LETTER OF SUBMITTAL
KFM Skyway Project # 04-012024

Subject: USI - Documents Clearing USI W M NCR #65 (METS#51)

Reference: SFOBB Skyway Project
USI #23932 (NCR LTR# 65.121604)

Subject: KFM/USI NCR No. 51: Deviating from Approved Fabrication Procedures (Fabrication of soffit plates pal 9 and pa20)

GIRDER 3A
PA 50

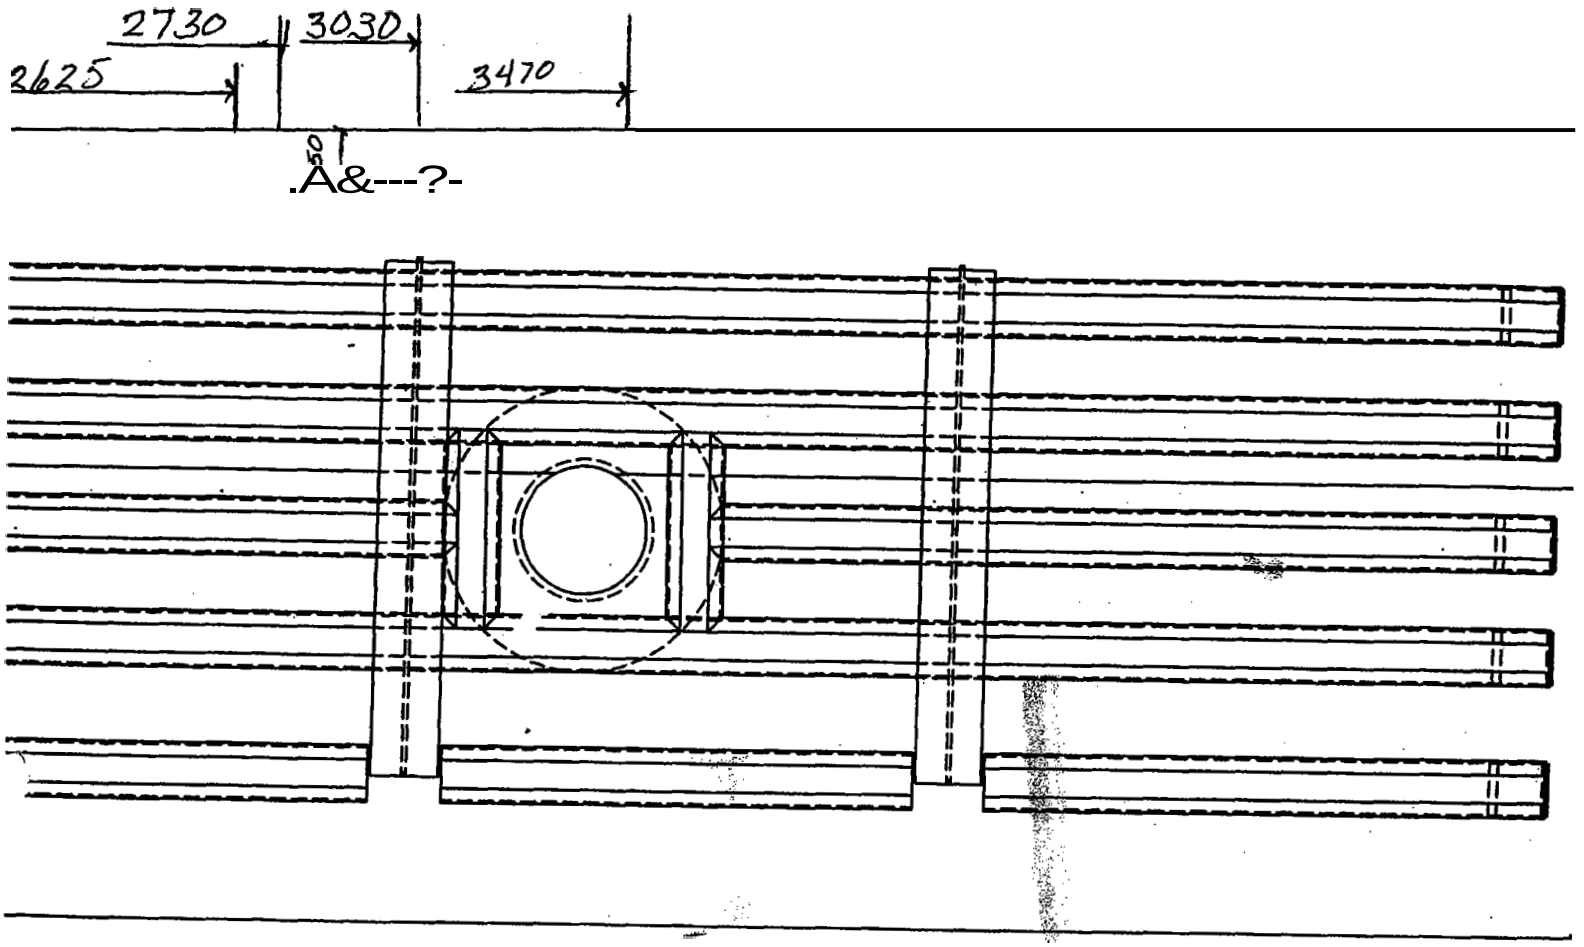
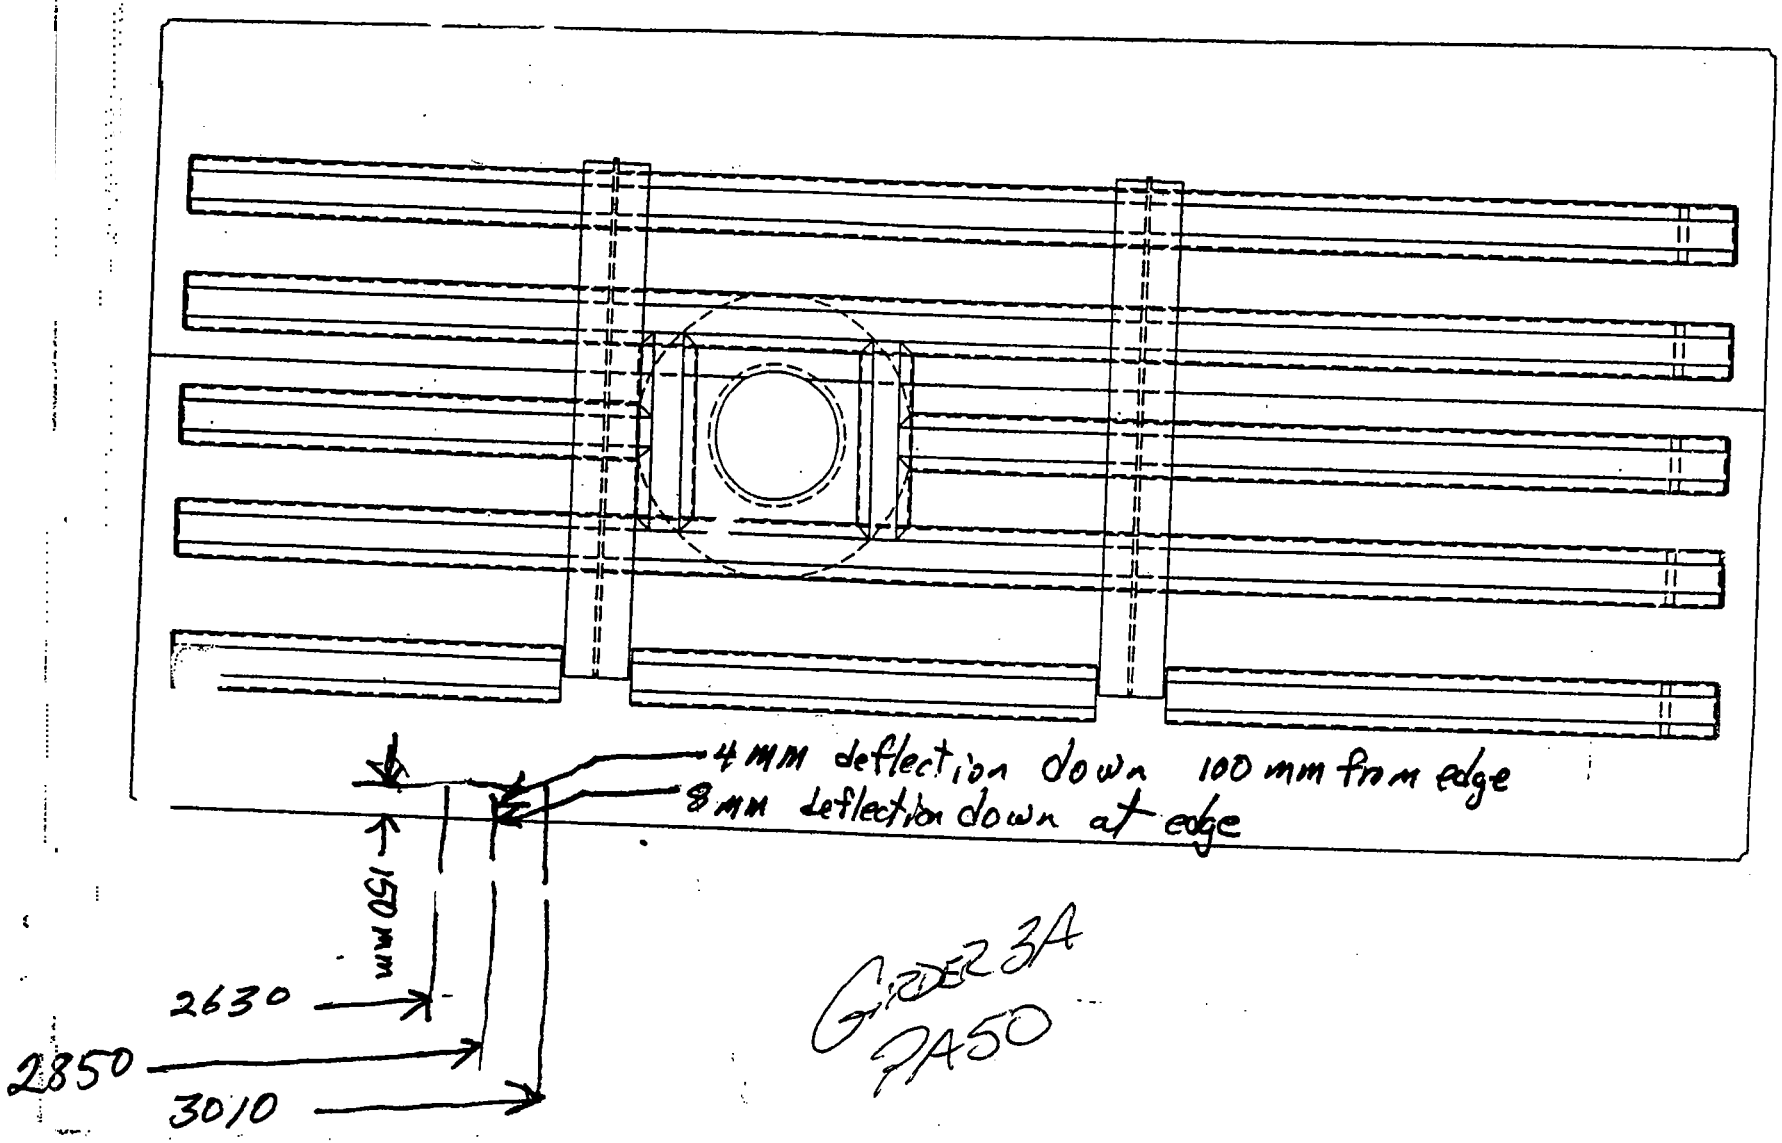
Web Pl. Pa50 There is a dent 380mm long by 150mm deep in top of web. 8mm max distortion. Per attached drg.

On Web PL Pa50; there is a dent 845 mm long by 250 mm deep on the top edge of the web PL. It is 13 mm maximum deviation from Straight It extends from 2625 from the left end to 3470 from the left end with the worst part being; from 2730 - 3030 mm. See attached sketch. This is a web For Girder #3

Restrain affected area + apply 3# strip heats as per attached sketch.

Apply Heat and/or Mechanical Assistance in affected area to Bring Within Tolerance

Pa24

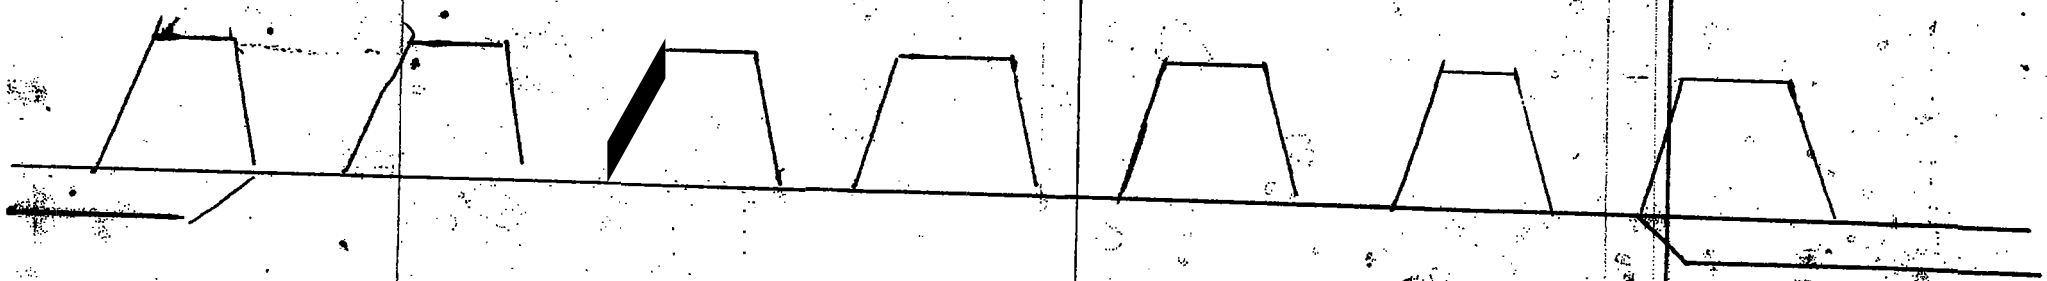
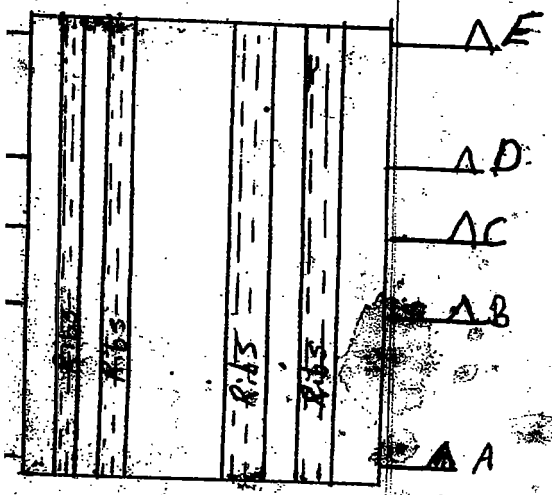
Step 1 - Details of Incident:
Pc 24 has weld distortion, (See attached sketch)

Step 2 - Corrective Action: Engineer approval required: yes (no)
THIS WAS REVIEWED BY THE PLANT MANAGER AND FOUND THAT THE OUT-OF-TOLERANCE WILL BE ELIMINATED AFTER FITTING DIAPHRAMS, T-STIFFENERS AND GUSSETS HAVE BEEN PERFORMED

Pa20

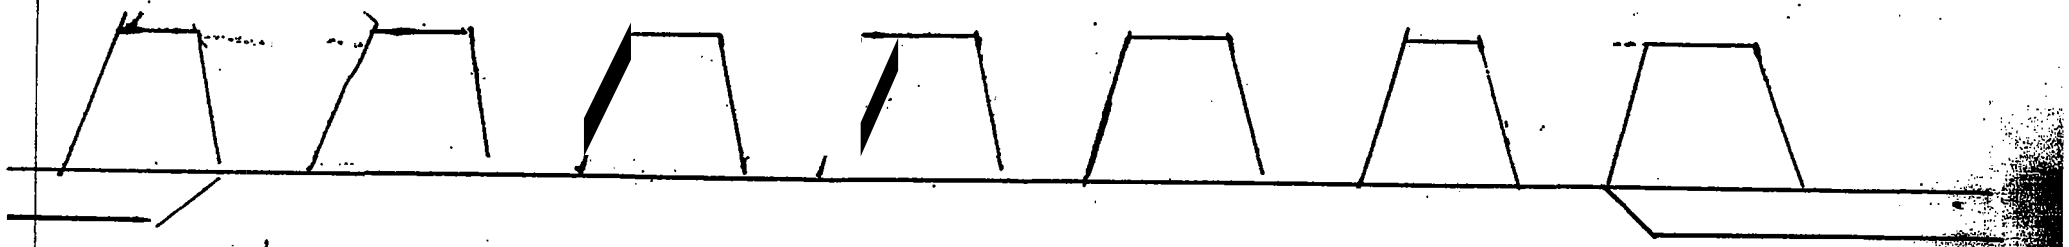
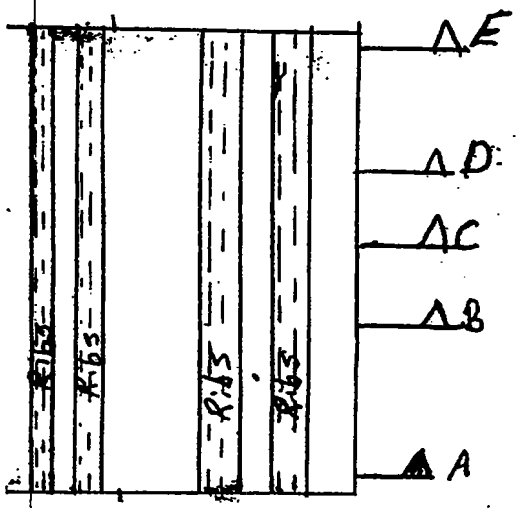
Girder 4A, Soffit plate pa20 has weld distortion. (See accompanying sketch)

This was reviewed by the Plant engr and found that the out of tolerance will be eliminated after fitting diaphragms, stiffeners, and gussets have been performed.

Wing Plate Pa28

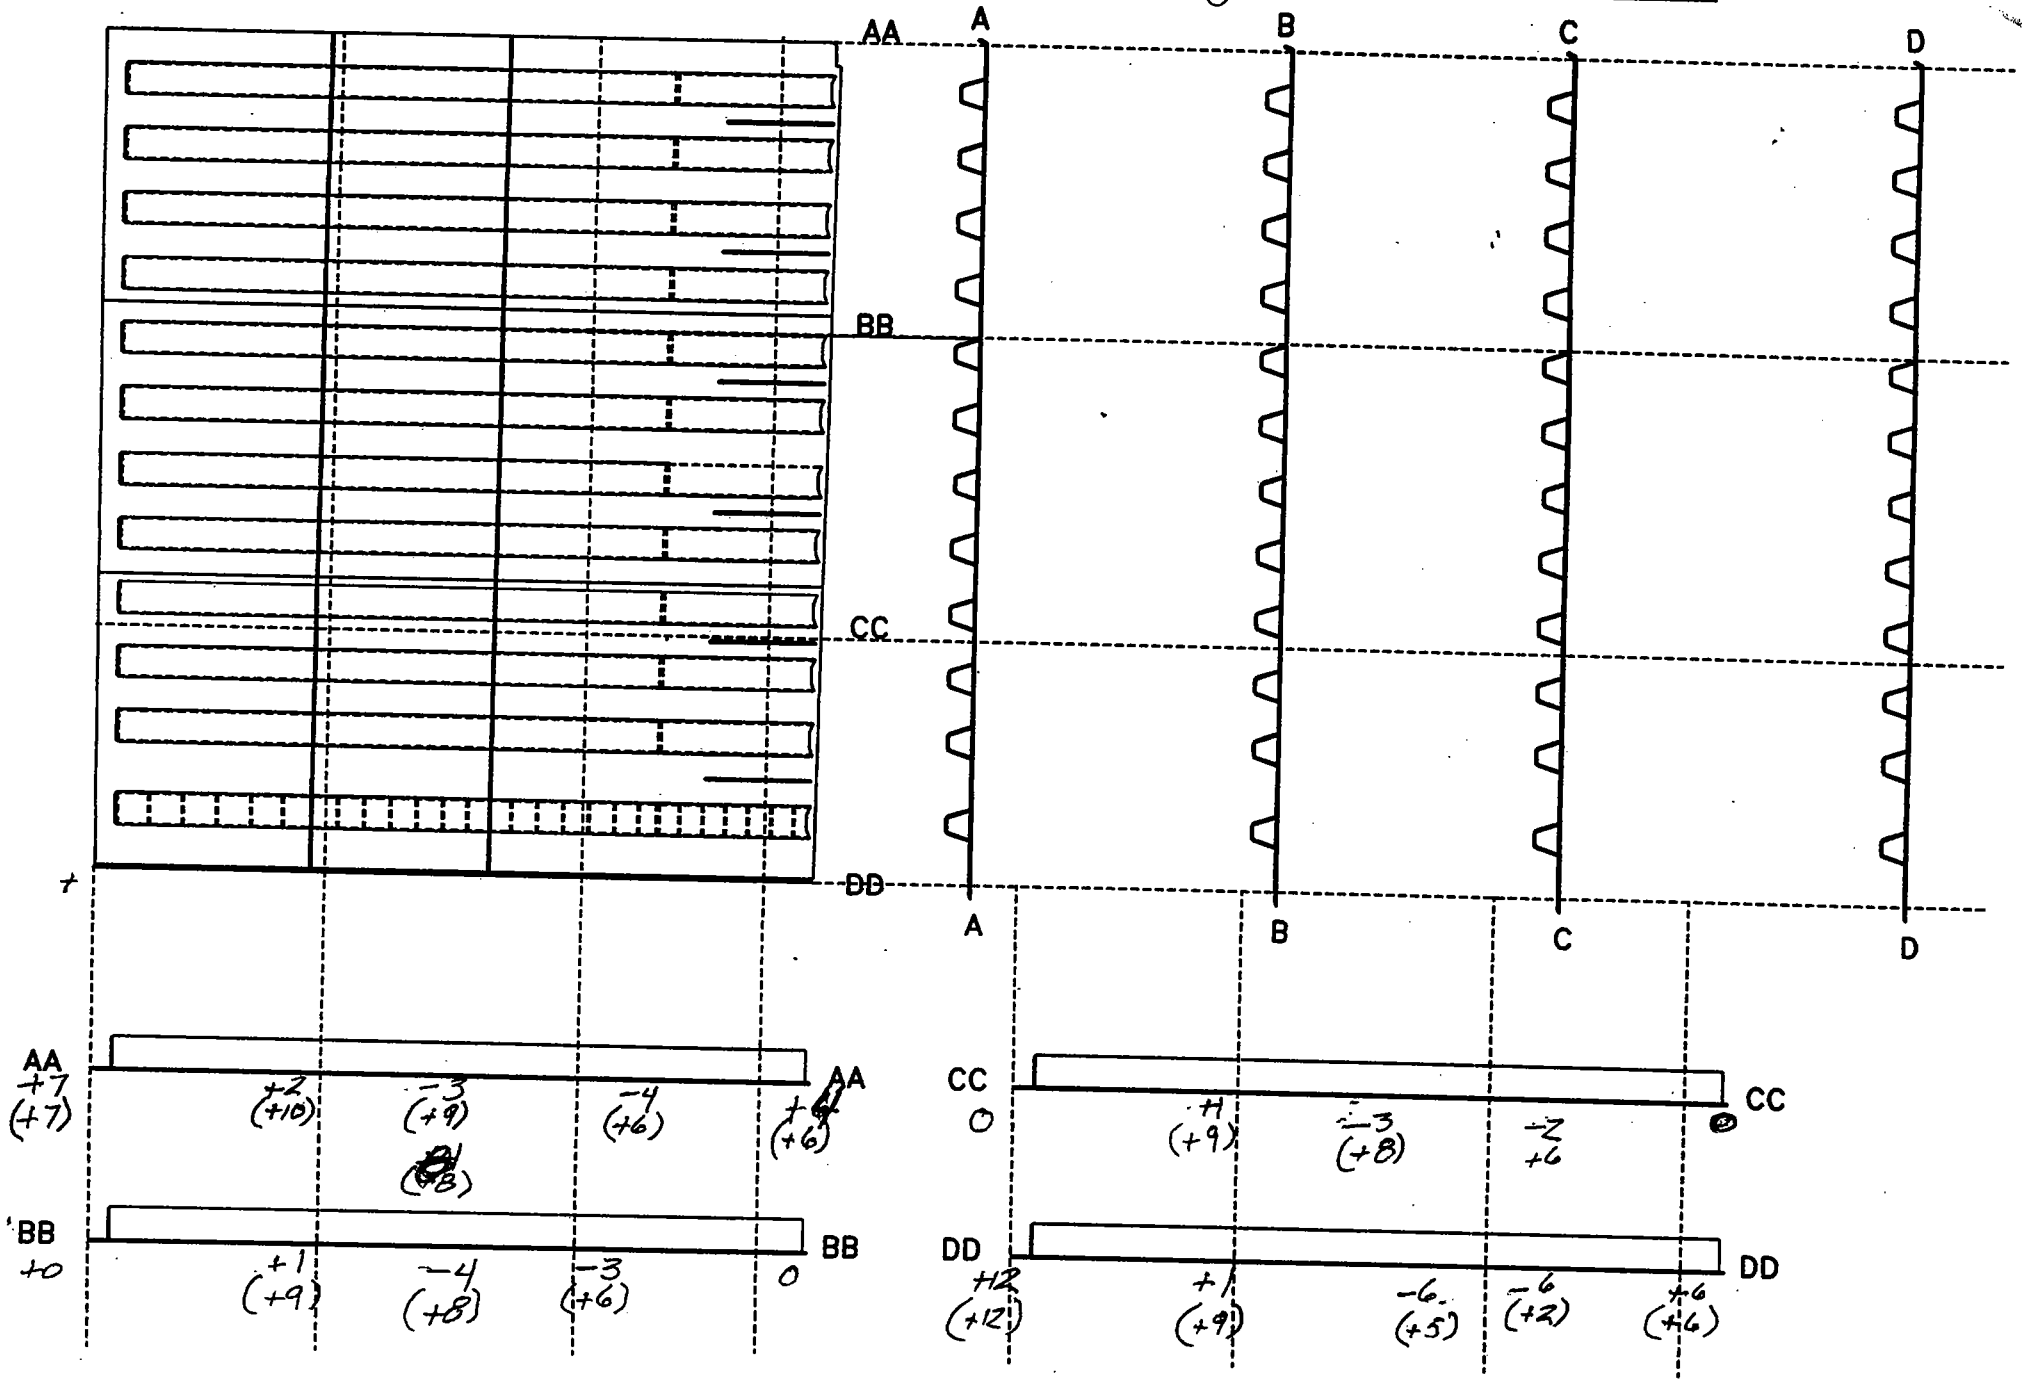
P28 is not flat. The accompanying chart illustrates the difference. The upper number represents the numbers in comparison with the bunking diagram. The lower number represents the actual number above zero

PA28 GIRDER 4A

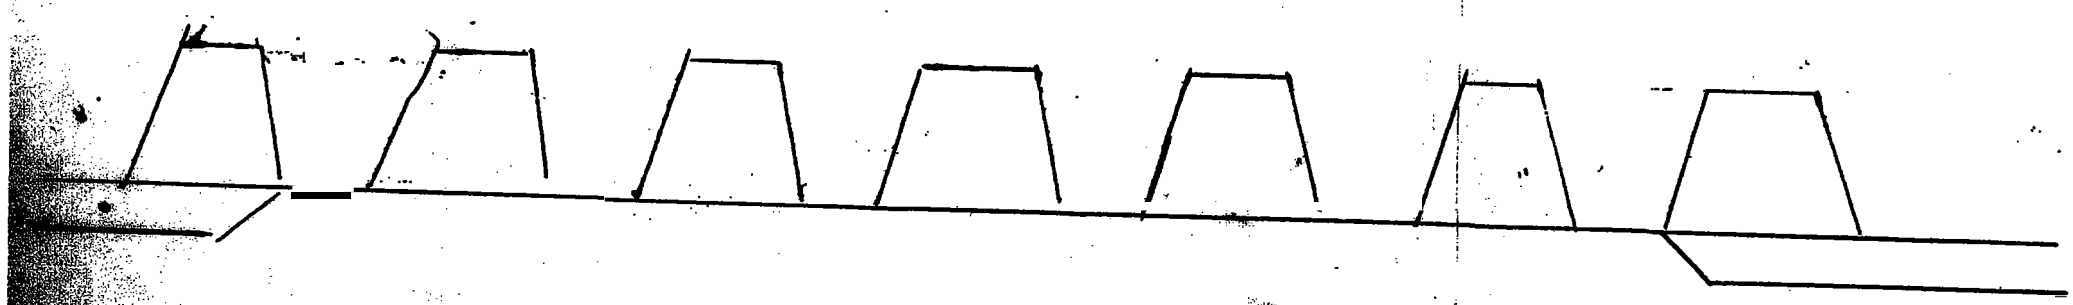
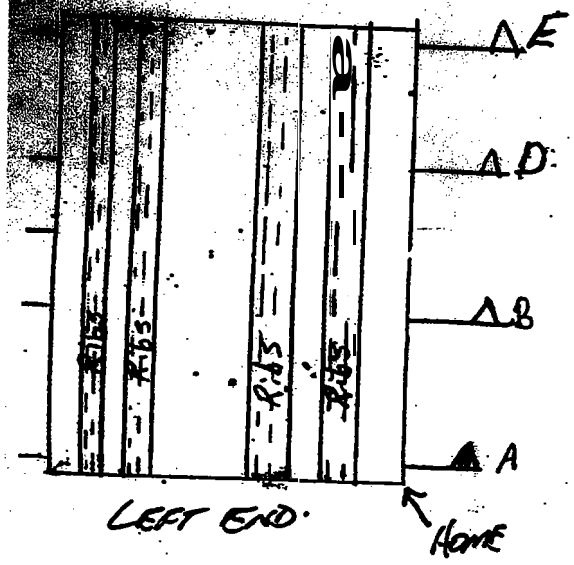
WING PLATE ASSEMBLY PA2B on GIRDER 4A HAS WELD DISTORTION - SEE ATTACHED SKETCH

THIS ISSUE WAS REVIEWED BY THE PLANT MGR. AND FOUND THAT THE OUT-OF-TOLERANCE WILL BE ELINNINATED AFTER FIT UP OF DIAPHRAMS, T-STIFFENERS AND GUSSETS HAS BEEN PERFORMED.
